UN#10-129

Subject: UniStar Nuclear Energy, NRC Docket No. 52-016  
Response to Request for Additional Information for the  
Calvert Cliffs Nuclear Power Plant, Unit 3,  
RAI 219, Response to Questions 02.05.01-66 through 69,  
Basic Geologic and Seismic Information

**Response to NRC RAI 219, Questions 02.05.01-66, 67, 68 and 69,**

Figure 2.5-26 (LiDAR Data for Calvert and St. Mary's Counties)

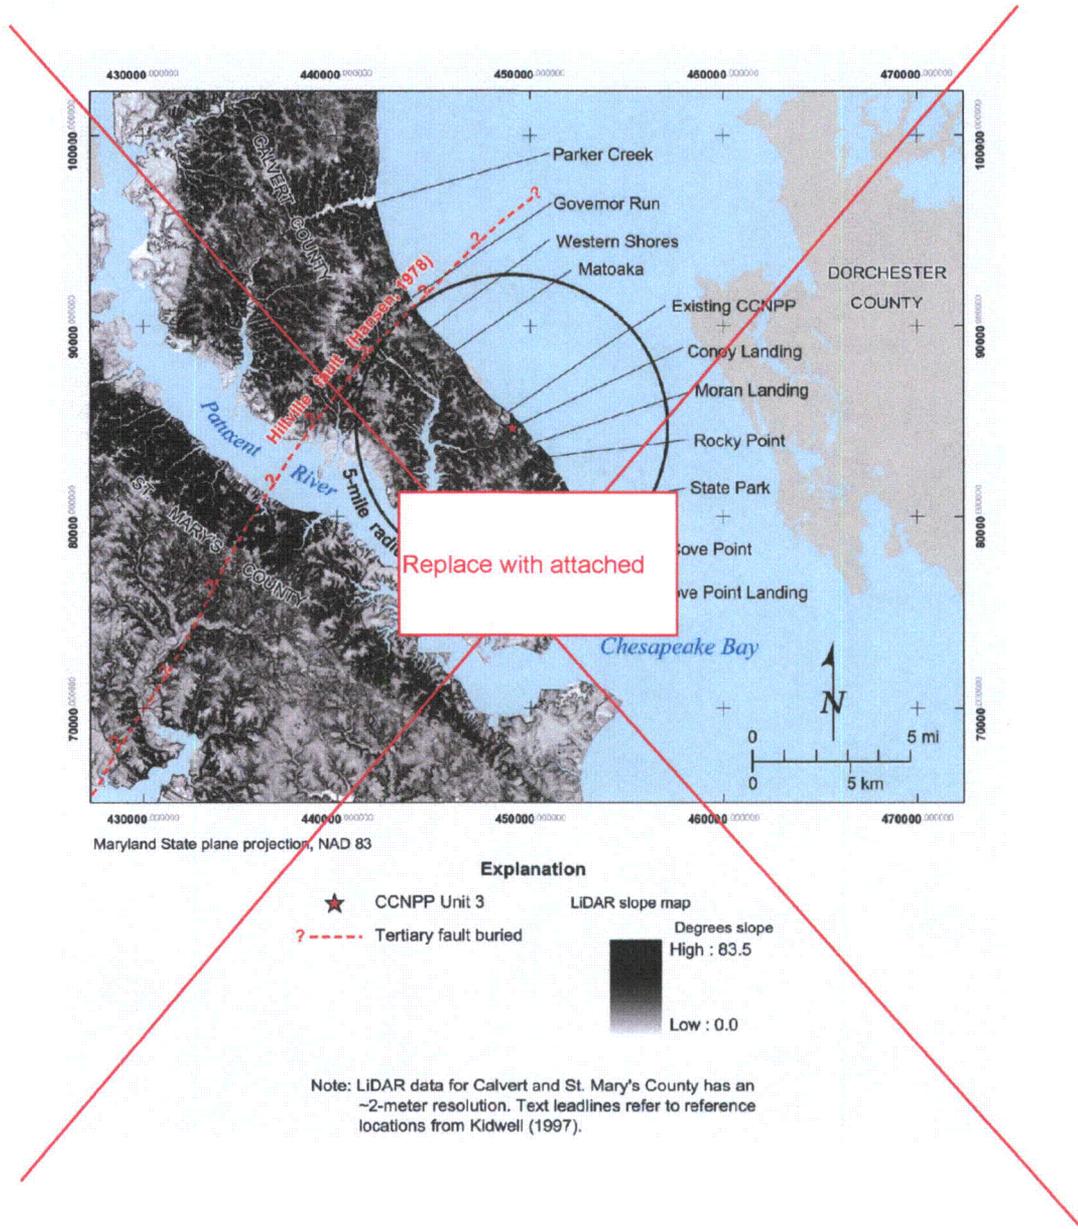
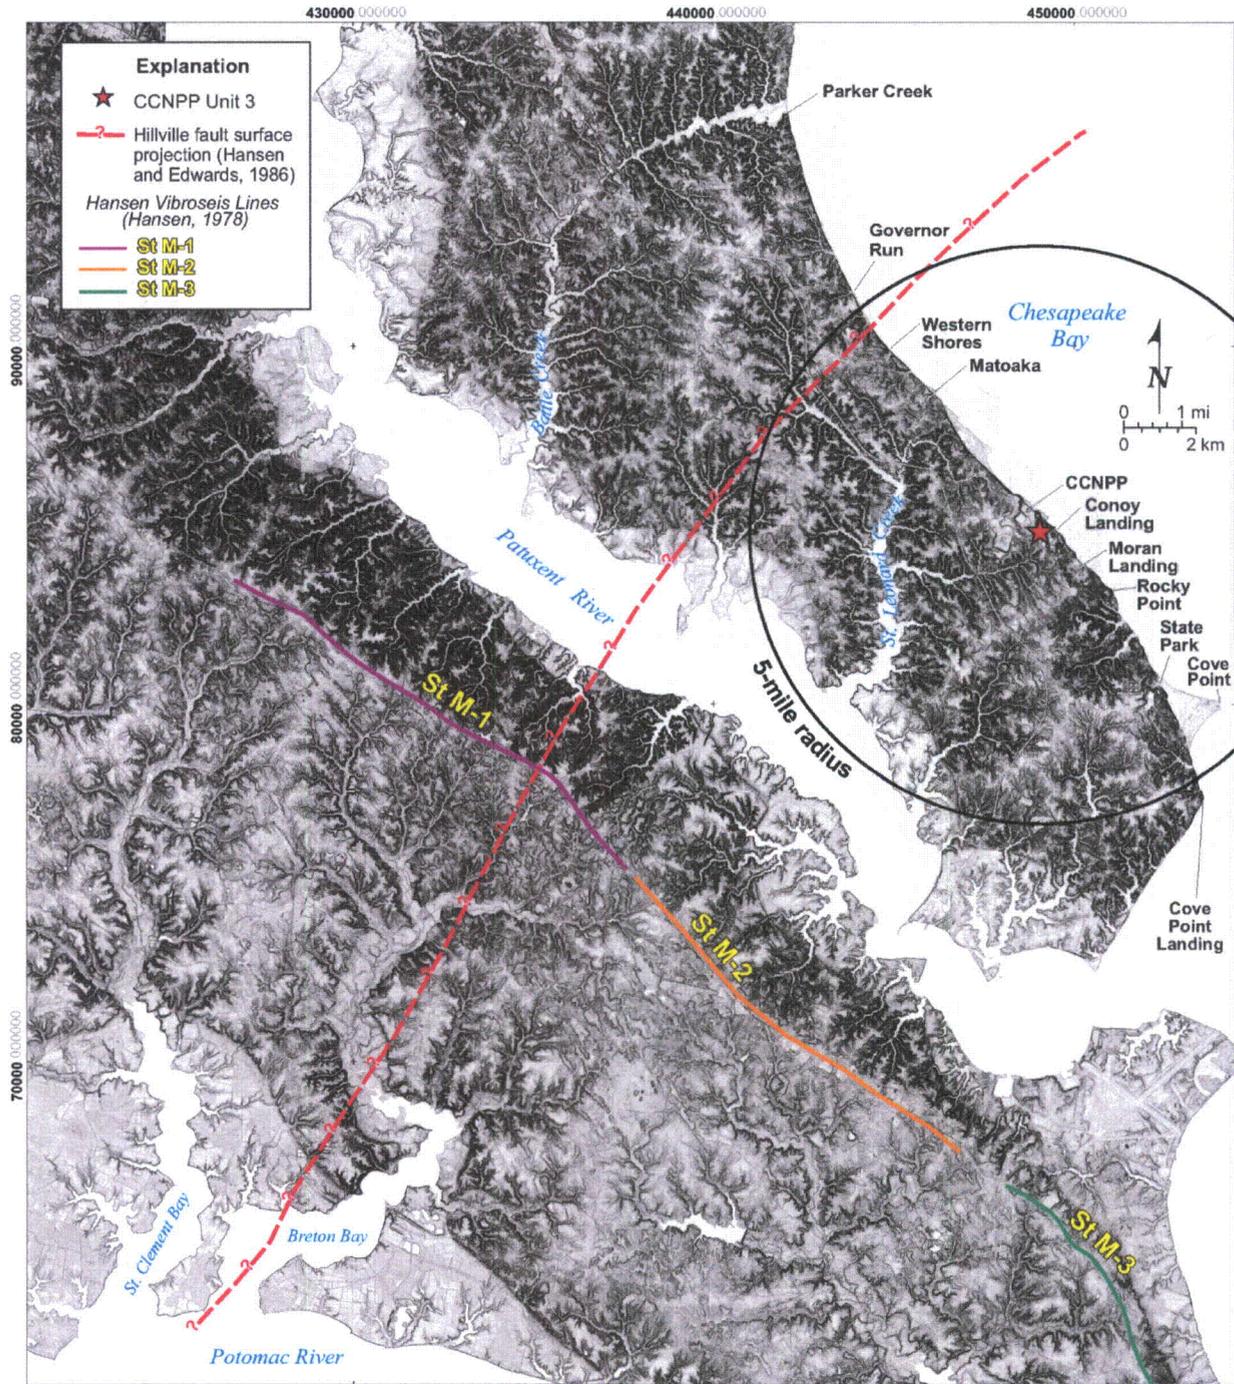
In your response, you stated that you plan no change to the FSAR. Please justify why the response figures and associated discussions should not be a part of the revised FSAR.

The figures and associated discussions provided in response to RAI 02.05.01-18<sup>1</sup> will be incorporated into the FSAR Subsections 2.5.1.1.4.4.4.5 and 2.5.3.2.1. Figure 1 from the response will be added as FSAR Figure 2.5-305. This figure is a reproduction of Figure 15 from Hansen (1978) showing the interpretation of the St-M-1 seismic reflection data. In addition, the existing FSAR Figure 2.5-26 will be replaced by Figure 2 from the RAI 02.05.01-18<sup>1</sup> response.

Figure 2.5-26 is updated as shown and two new figures, Figure 2.5-301 and Figure 2.5-305 are added. Figure 2.5-301 was also submitted with the response to Question 02.05.01-64<sup>3</sup>.

Figure 2.5-305 {Seismic Reflection Line St. M-1 Showing Hillville Fault of Hansen (1978)}

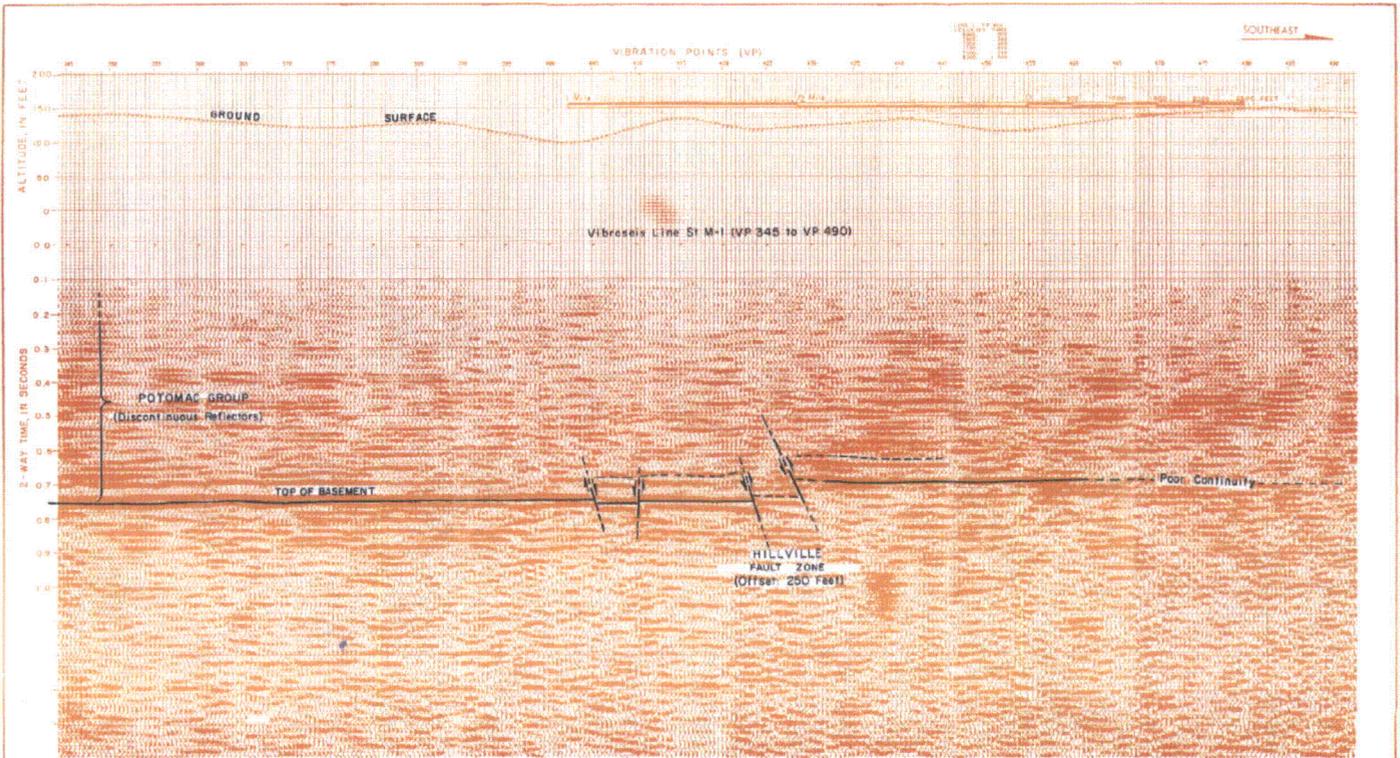
FSAR, Section 2.5.1.1.4.4.4.5, Hillville fault zone, refers to seismic reflection data to support the presence of the Hillville fault, within 5 miles of CCNPP. In RAI 02.05.01-18, the NRC staff asked for a copy of the seismic line St-M-1 and asked about the fault possibly being captured in the extensive marine seismic data taken in the Chesapeake Bay, to the east of the land-based seismic reflection line.

Figure 4. Geologic cross sections from Spesutie Island to Turkey Point to Grove Point illustrating unfaulted Potomac Formation (modified from Benson, 2006).

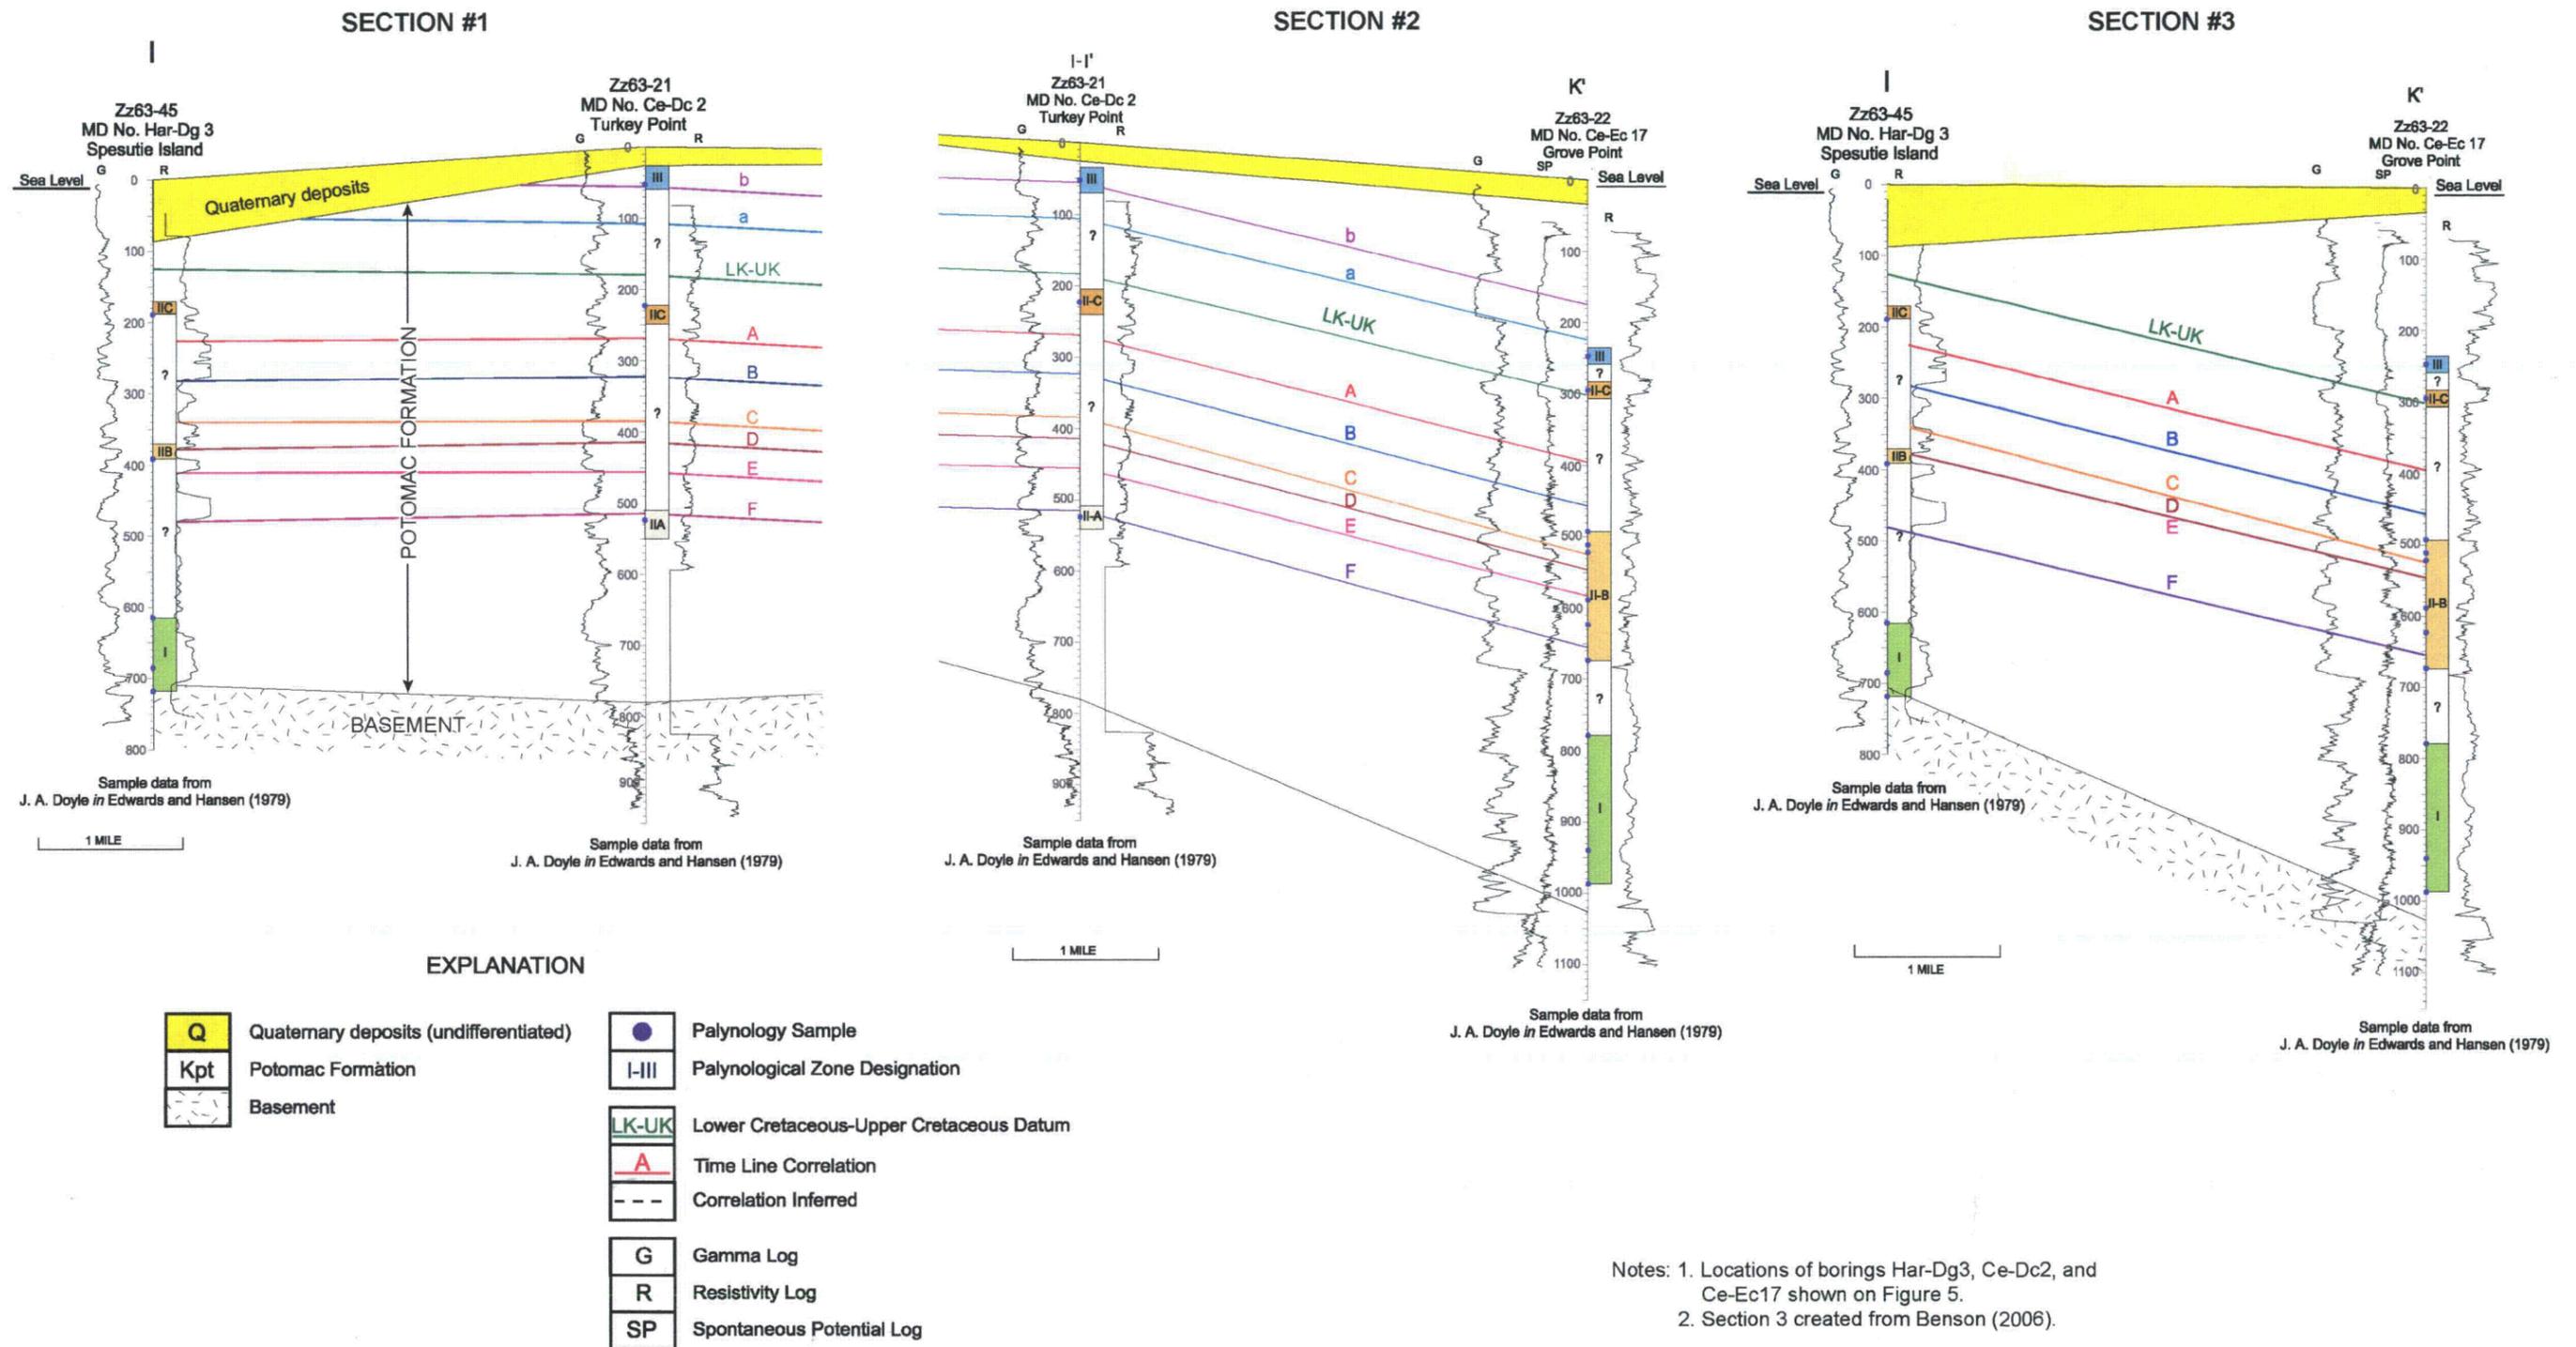
- **The bathymetric profile across the bay in Figure 4 indicates a smooth profile but the scale of presentation does not permit close examination of the profile. The offshore location of the fault could be located just off shore from Turkey Point, in the thalweg channel of the Susquehanna River. Newell et al, 2004 interpreted recent river/deltaic deposits along the base of the bay, almost as far south as Annapolis. These deposits could mask a small surface expression of a submarine fault.**

We interpret the profile discussed in the statement above is referring to geologic cross section A-A' (included as Figure 6) that illustrates both topography and bathymetry. This profile has a vertical exaggeration of over 67 times intended to "permit close examination of the profile". Any resolvable deflection in the base of the Northeast River should be detected at this scale. The above statement was provided as indirect evidence of the absence of obvious submarine geomorphology that could be associated with the hypothesized fault from Pazzaglia (1993a). However, as the statement above notes, the profile cannot preclude faulting that may be masked by recent river deposits. The above quotation was not intended to preclude faulting within buried fluvial units.
